SUBDIVISION REVIEW SHEET**CASE NO.:** C8-2016-0247.1A**P.C. DATE:** September 8, 2020**SUBDIVISION NAME:** Pioneer Crossing East Section 19 Final Plat**AREA:** 7.15 acres**LOTS:** 32**APPLICANT:** Continental Homes of Texas, LP
(Kevin Pape)**AGENT:** LJA Engineering, Inc.
(Justin D. Midura, P.E.)**ADDRESS OF SUBDIVISION:** Samsung Blvd. & 200-751 E. Braker Lane**WATERSHED:** Walnut Creek**COUNTY:** Travis**EXISTING ZONING:** P.U.D**JURISDICTION:** Full Purpose**PROPOSED LAND USE:** Residential**VARIANCE:** none**DEPARTMENT COMMENTS:**

CITY OF AUSTIN –DEVELOPMENT SERVICES DEPARTMENT
SUBDIVISION APPLICATION – MASTER COMMENT REPORT

PROJECT NAME: Pioneer Crossing East Section 19 Final Plat
LOCATION: 200-751 E BRAKER LN

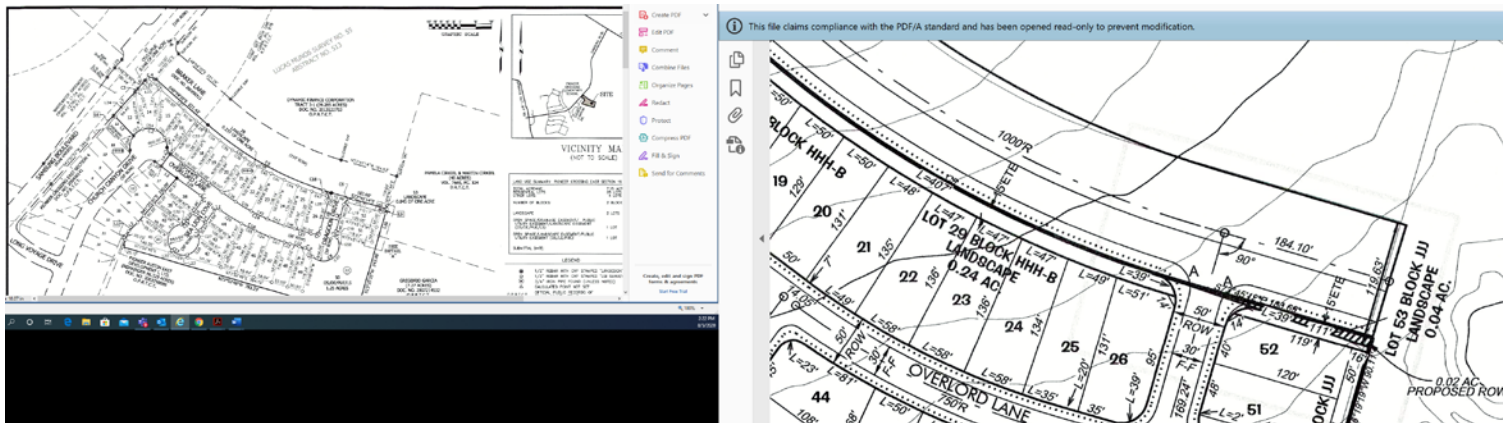
ATD 1. The proposed final plat does not appear to match the preliminary plan. In prior discussions regarding the preliminary plat, ATD and the applicant agreed upon the inclusion of a small sliver of additional right-of-way in order to accommodate the planned alignment of the Braker Lane extension. An additional .02 acres of right-of-way was added to the eastern end of Braker Lane right-of-way to terminate at 119.63' ROW width. Approved prelim. shown on the right below:

U1: Comment cleared.
